Council of the European Union

**6214/17
ADD 1**

From:	European Commission
date of receipt:	3 February 2017
To:	General Secretariat of the Council
No. Cion doc.:	D048925/03 - Annexes 1 to 3
Subject:	ANNEXES to the Commission Regulation (EU) .../... correcting Directive 2007/46/EC of the European Parliament and of the Council, Commission Regulation (EU) No 582/2011 and Commission Regulation (EU) YYYY/XXX [WLTP]

correcting Directive 2007/46/EC of the European Parliament and of the Council, Commission Regulation (EU) No 582/2011 and Commission Regulation (EU) YYYY/XXX [WLTP]

Figure 1

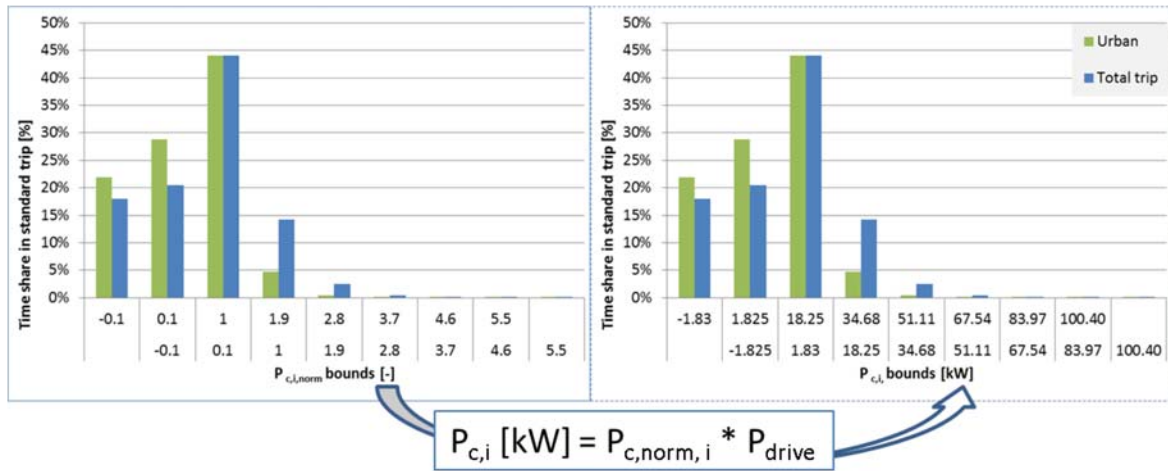
(v) point 3.4.2. is replaced by the following:

3.4.2. Correction of the wheel power classes

The maximum wheel power class to be considered is the highest class in Table 1 which includes (P_{rated} x 0.9). The time shares of all excluded classes shall be added to the highest remaining class.

From each $P_{c,norm,j}$ the corresponding $P_{c,j}$ shall be calculated to define the upper and lower bounds in kW per wheel power class for the tested vehicle as shown in Figure 1.
